## Panda All versions

### FUEL VAPOUR RECIRCULATION VALVE

Service solution for cases of noise

# Service News

FIG. A

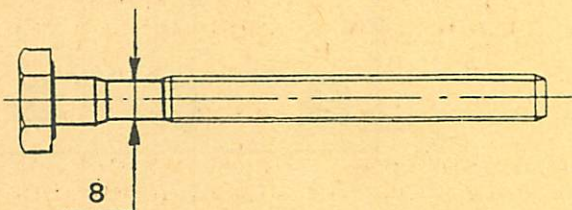
Torque + angle tightening system adopted and  
cylinder head gasket with relevant screws  
consequently replaced.

- Screws as per figure A
- Cylinder head gasket with silicone added on one side only
- Screws torque tightened to 6 daNm

- Screws as per figure B
- Cylinder head gasket with silicone added on both sides
- Screws torque + angle tightened to 3 daNm + 90°+90°.

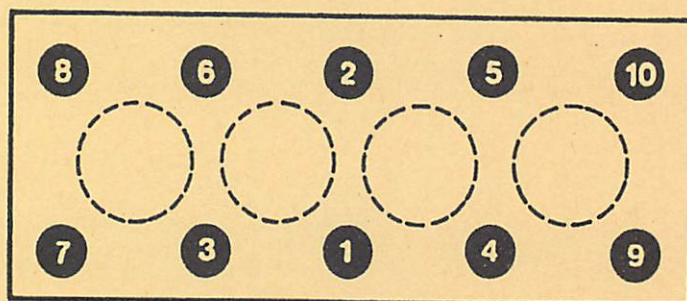
Cylinder head screws are to be tightened according  
to the sequence shown in the figure.

- 1) Lubricate screws and washers with VS 30 oil and let them drip 30 minutes at least.
- 2) Tighten the screws to 2 daNm
- 3) Torque tighten to 3 daNm

- 4) Additionally tighten the screws with a standard wrench by a 180° angular rotation in two distinct steps (90°+90°) according to the sequence prescribed.

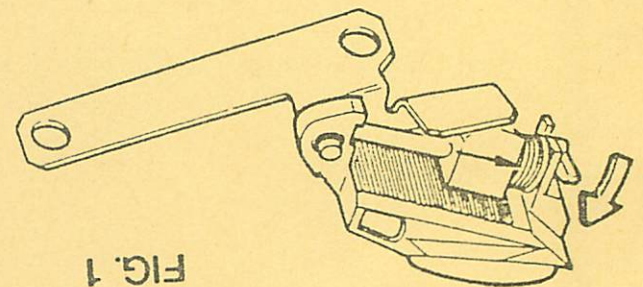
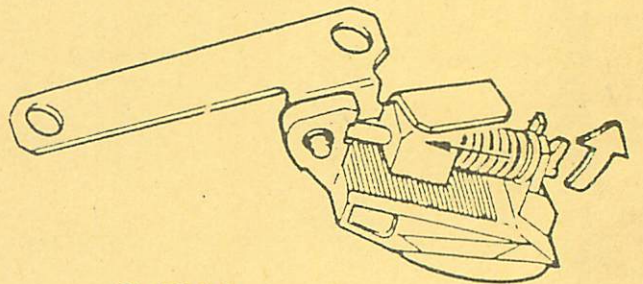
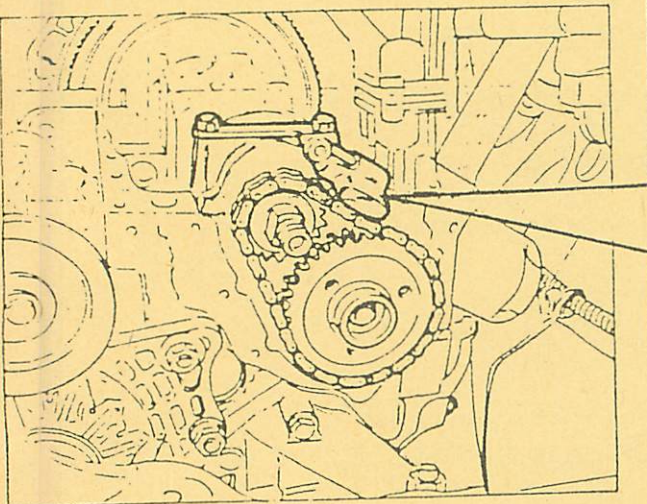
- After having replaced chain and gears and before fitting the cover, fit the shoe part no. 7661126 with bracket no. 7711828, fixing it by ring part no. 11087776. All the above parts are available as spare.
- Fit shoe-bracket assembly under support no. 1 of crankshaft (see fig. 2)
- Tighten support bolts at 6.9 daNm
- Rotate plastic lever of 60...90 degrees alternatively, in order to disengage tensioning spring of the shoe (see fig. 3)
- Fit the new cover part no. 7663711

FIGURE 1

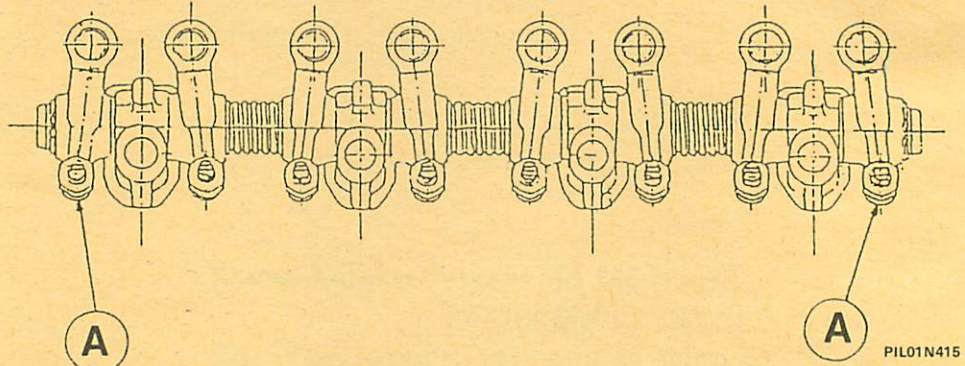
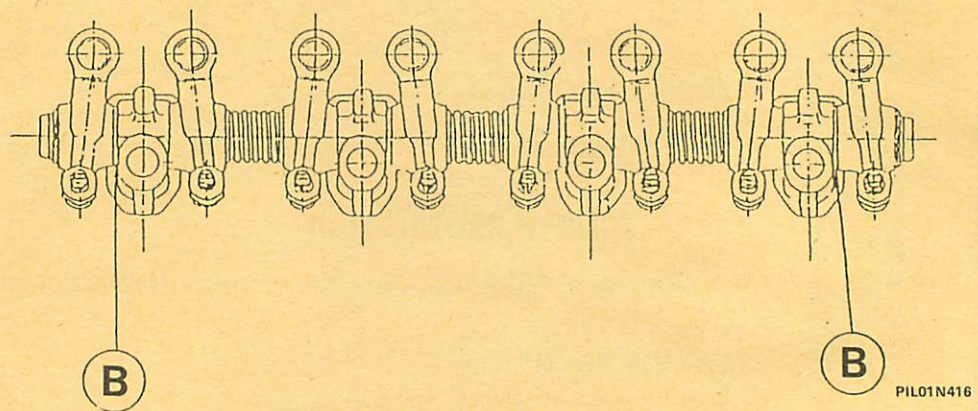
- Remove the rocker arm shaft.
- Remove rocker arms 1-8 from the shaft (A in figure 1).
- Replace the two thrust washers shown in figure 2 with different ones ordered from the Parts Division by quoting no. 46419826.
- Refit the rocker arms.
- Fill the tappets with oil as described in the Service Manual.
- Refit the rocker arm shaft.

A) Rocker arms 1-8

B) Washers to replace

A) Float valve

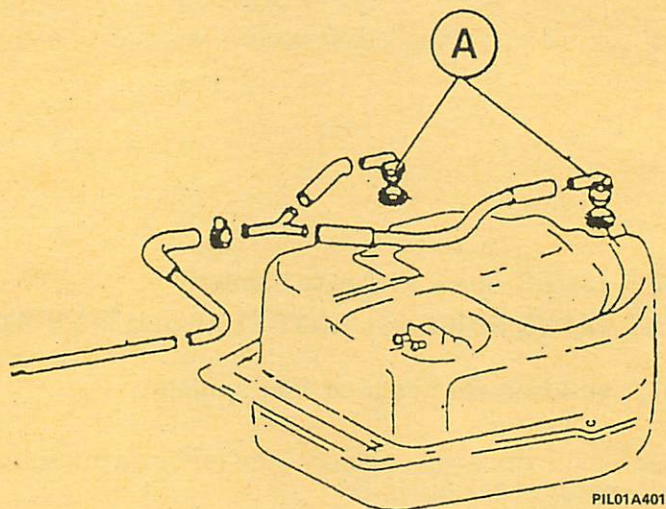
Replacing the float valve with a modified one supplied by the Parts Division no. 7689120 which although it is the post-modification type can be either white or grey.

- Remove the petrol tank.
- Replace the two float valves with new ones ordered from the Parts Division no. 7689120.
- Refit the tank.

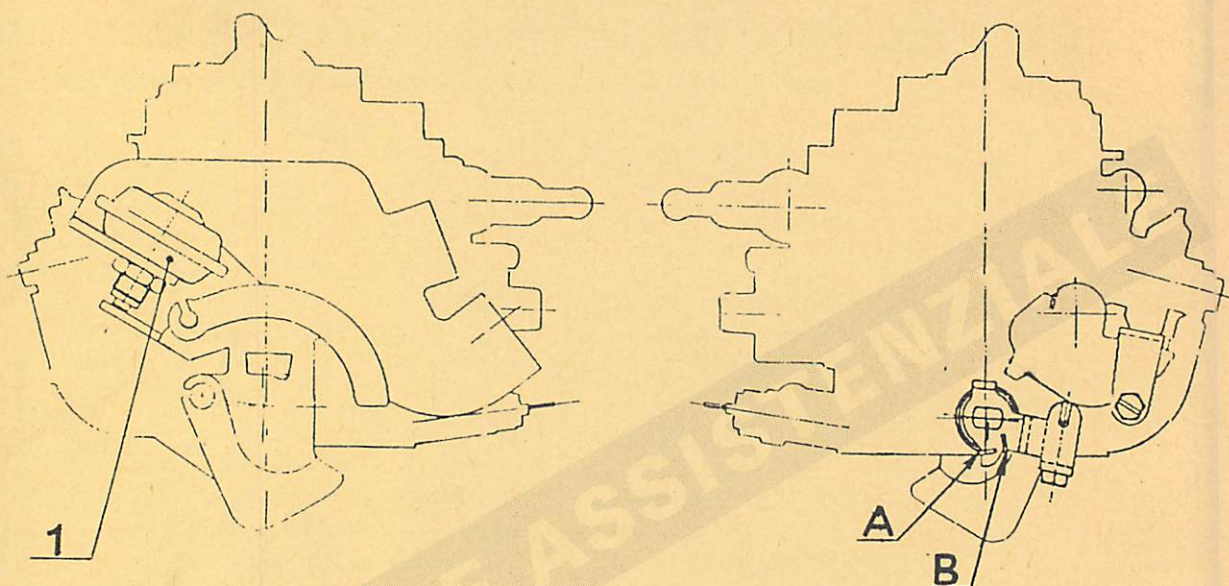
In case of excessive accelerator load which could occur on the first units produced since they are equipped with accelerator return spring calibrated at higher load and "Dash-Pot" device (1 " in figure) proceed as follows:

- remove "Dash-Pot" device (1 in figure) by slackening the screws securing it to carburettor
- acting with a screwdriver on throttle valve axis move return spring hooking from "A" to "B" position shown in the figure so that spring load is reduced.

1 = "Dash-pot" device (to be suppressed)

A = spring position with higher load

B = spring position with lower load (to be obtained by service solution)
